**RESPONSE TO OBSERVATIONS  
(ABP-321454-24)**

**Brittas Wind Farm**

**Orsted**

**1 September 2025**

Figure 1: National Monuments in State Care identified within c.10km radius from the Proposed Wind Farm ([www.archaeology.ie](http://www.archaeology.ie)).

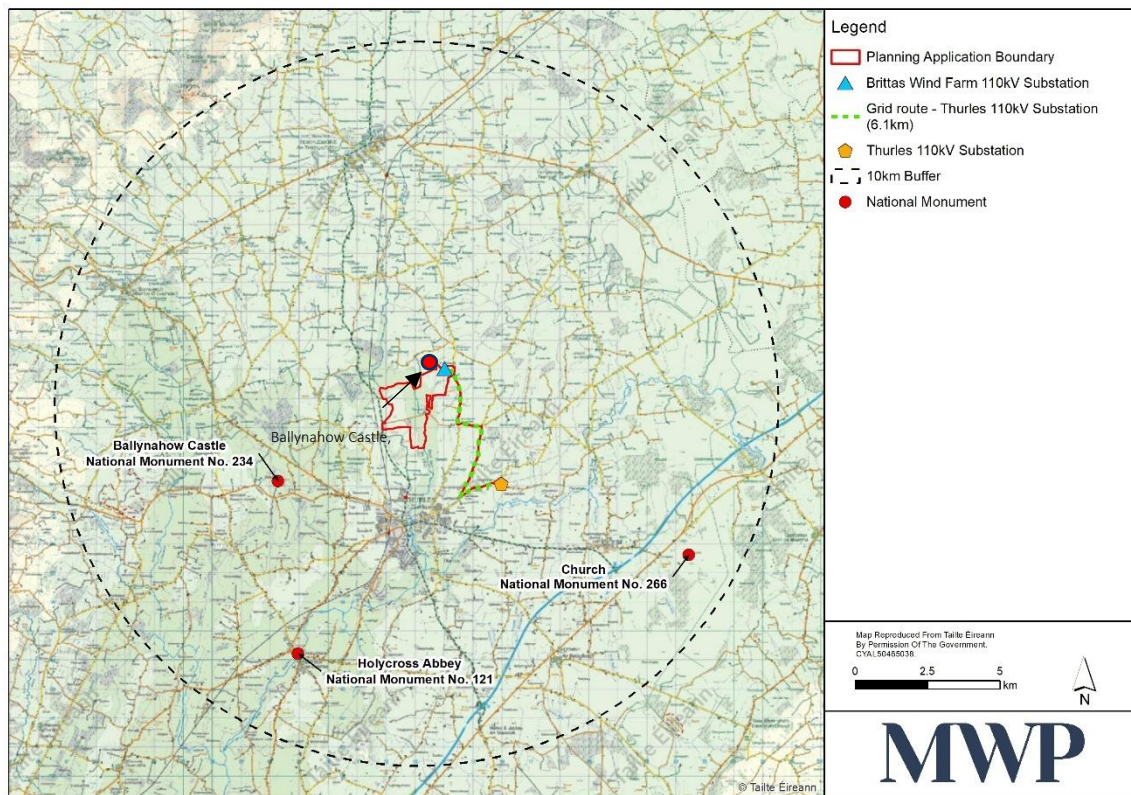
This section responds to three specific issues raised by the OPW about the assessment of cultural heritage effects on the following three monuments:

The location of these monuments is illustrated in **Figure 1**. These three National Monuments are located within c.10km radius from the Proposed Wind Farm. These are: two early medieval churches at Leigh townland (National Monument No. 266) and Holycross Abbey (National Monument No. 121) and Ballynahow Castle / Tower House. There are no National Monuments in State Care within the Proposed Wind Farm.

**Figure 6: Location of the Creamery and Thurles Water Tower Source relative to the proposed Brittas WF and Grid Route.**

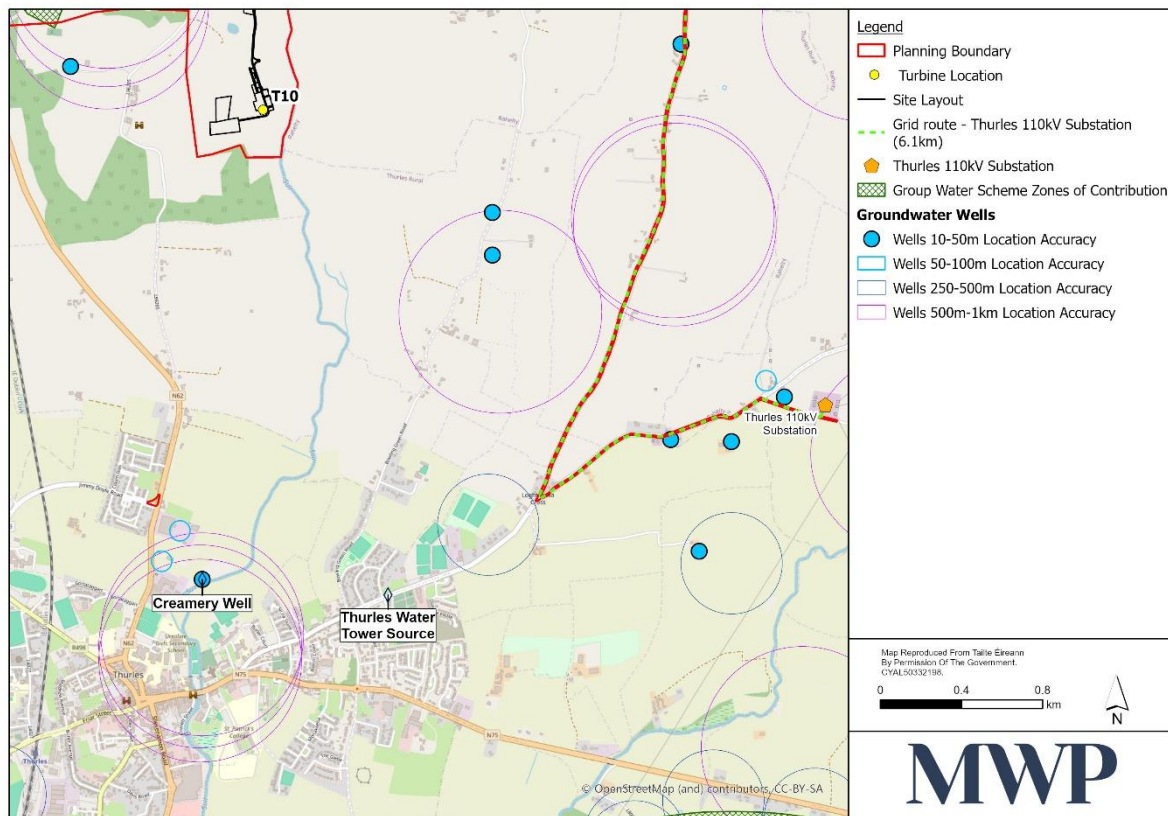
The applicant has not included any of the Uisce Éireann Public Supplies Table 9-9 & Figure 9-18, with particular reference to the Thurles Water Tower and Creamery Well groundwater supplies.

While section 9.4.3.7 of Chapter 9 (Water) in EIAR Vol. 2 has assessed the potential effects of the project works on groundwater and Local Well Supplies and found these to be slight, the earlier discussion of the local wells in section 9.3.5.3 did not specifically mention or profile the Uisce Éireann Creamery and Thurles Tower wells. As indicated in **Figure 10** below, the Creamery Well is located 2.36km south of the nearest Turbine (No,10) and is located adjacent to the River Suir. The Tower well is located 855m south-west of the nearest point of the proposed Grid route. Consequently, neither of these wells will be directly affected by the proposed works. Any potential indirect effects on water quality would be effectively mitigated by the standard water quality mitigation measures proposed in the EIAR and incorporated into the project design (see section 9.4.2 of Chapter 9 of the EIAR Vol. 2). These measures will effectively ensure that there is no significant effect on the local wells and their associated zone of consideration/abstraction.

During the construction phase, the grid route cable will be installed under existing road corridors and the proposed access tracks. Crossing a groundwater abstraction catchment with underground infrastructure carries potential risks, particularly where critical recharge zones or areas of high groundwater vulnerability are present. However, the cable trench will be narrow and shallow relative to the groundwater table at approximately 1.2–1.5 metres deep. Consequently, as the duration of these effects will be temporary, the magnitude will be low and the significance of the effects slight and indirect.

To manage these potential impacts, construction activities will be governed by the Construction Environmental Management Plan (CEMP), which will include site-specific pollution control measures such as hydrocarbon

bunding and emergency spill response protocols. Refuelling, plant maintenance and chemical storage will also be restricted to designated areas of the site compound. See sections 4.1.8 and 4.1.9 and EMP 2, EMP 3 and EMP 4 in the CEMP.

**Appendix 2: View from viewpoint 14 at the Holycross Abby towards the proposed Brittas WF**

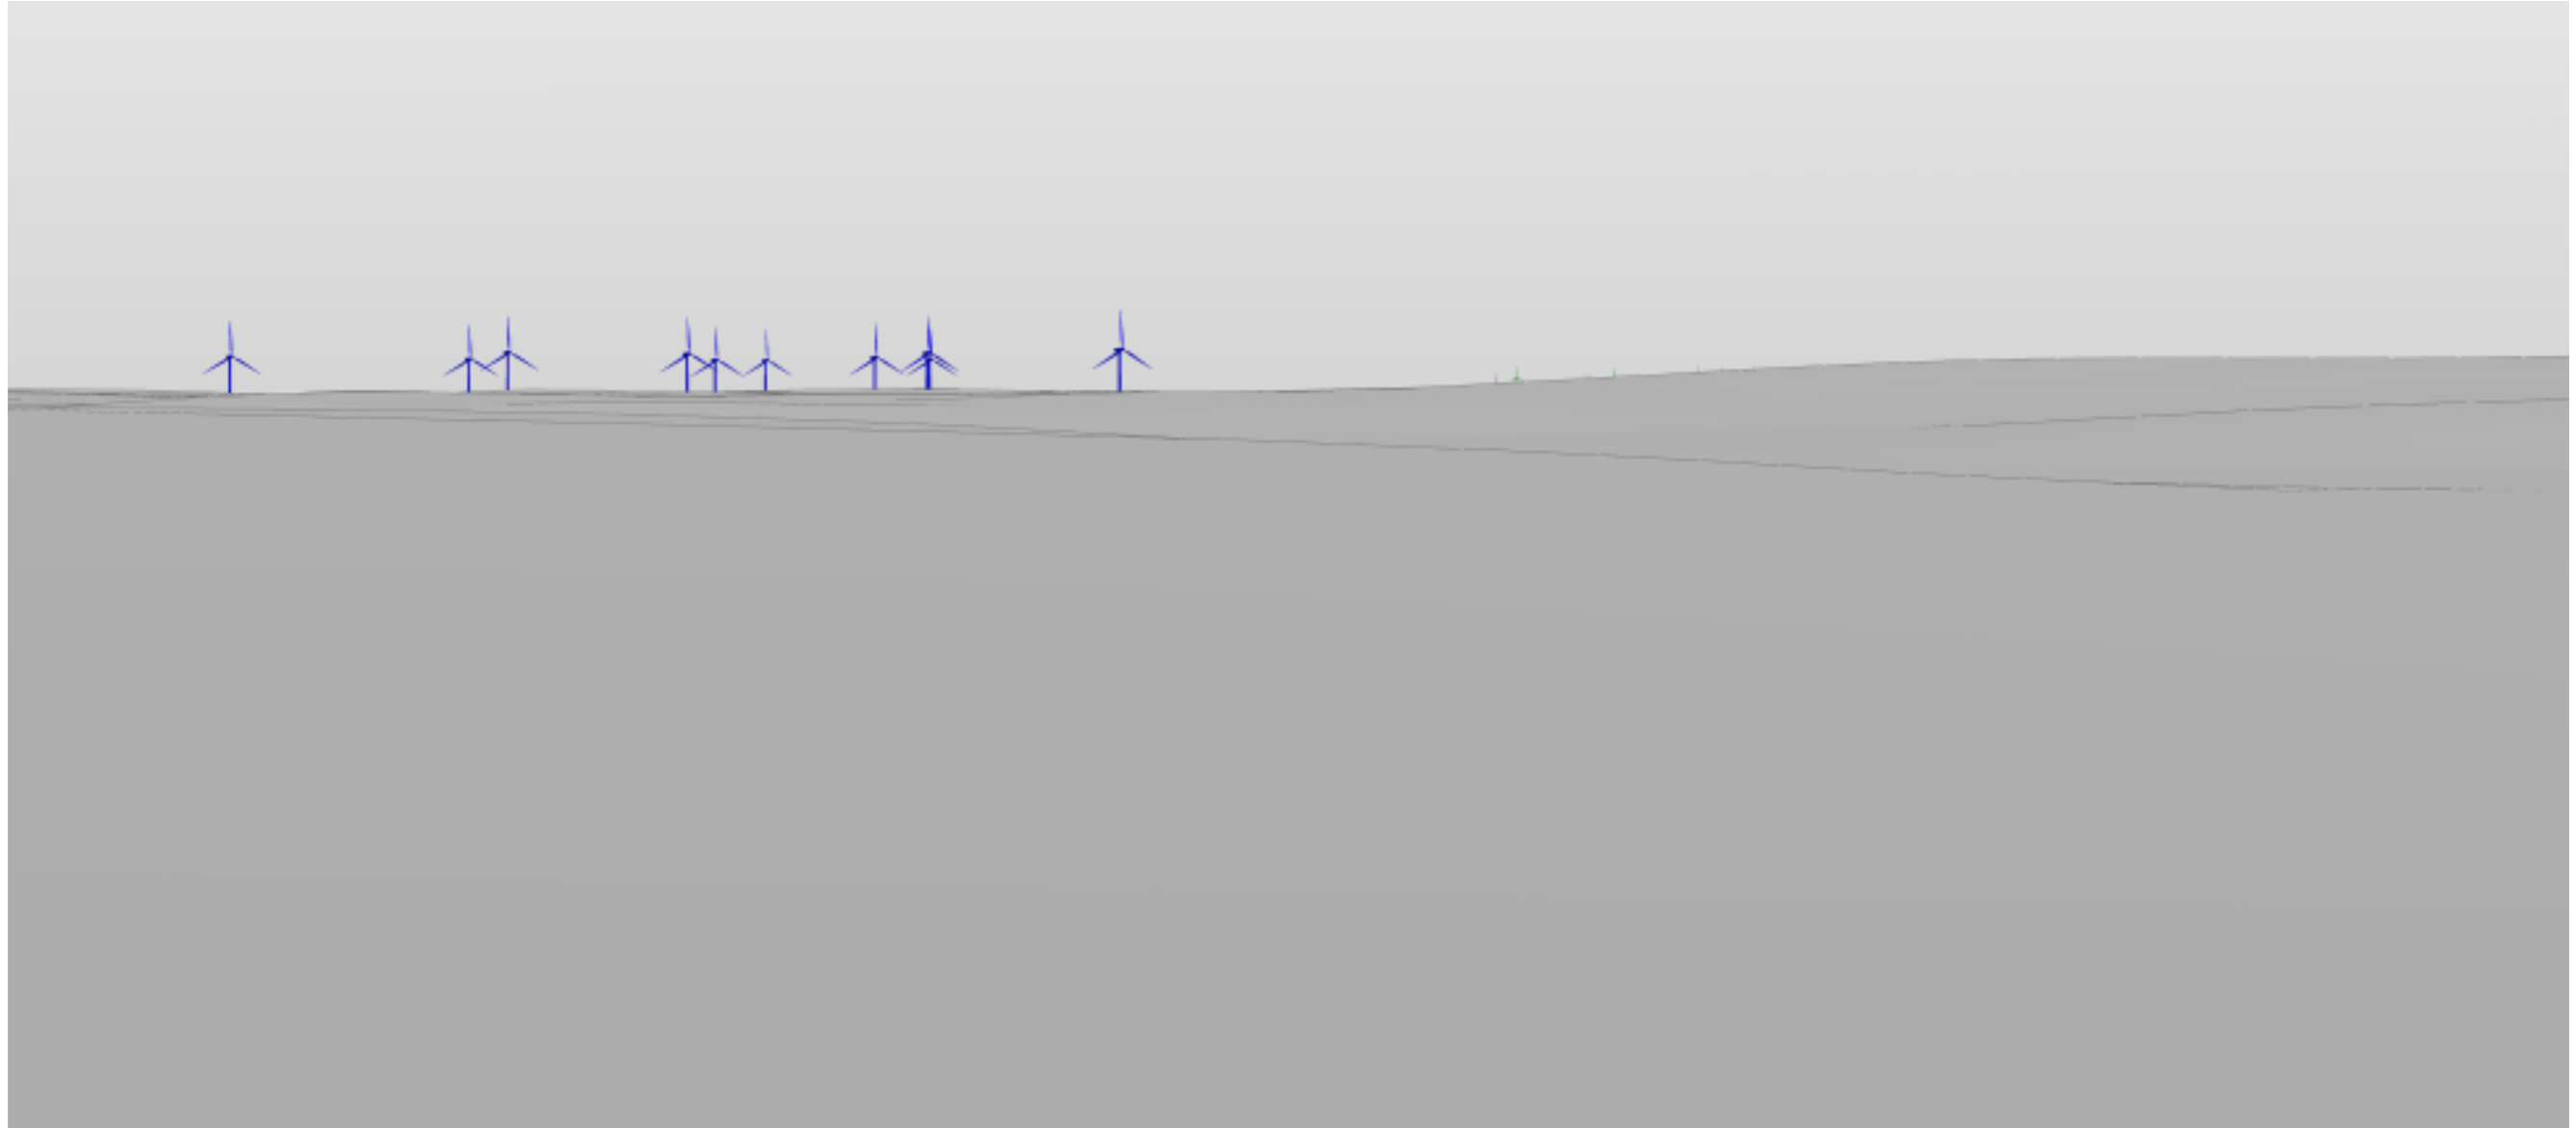
*The planning application assesses Viewpoint 14 (Holycross Abbey, NM No. 121) as a receptor of High- Medium sensitivity. The OPW is concerned that as the photograph was taken in the spring/ summer with full foliage and bloom, and that 'screening by the intervening vegetation/ buildings' may be less effective in the other 6 months of the year.*

The Holycross Abbey is located c.8km to the SW of proposed planning boundary and it is currently a significant tourist's attraction. The landscape in this area is relatively flat. Analysis of ZTV shows that all no 10 turbines will be theoretically visible from the location of the monument. However, results of the photomontage (see **Appendices 2 and 3**) revealed that this ecclesiastical site is surrounded by mature trees and houses. As the proposed turbines are below the height of the trees on the horizon, the turbines will consequently not be visible from the monument site during the summer when the trees are in full leaf and will be imperceptible in the winter. Considering this and the distance to the development, the likely cultural visual effect on the monument during operation phase is classified as not significant.
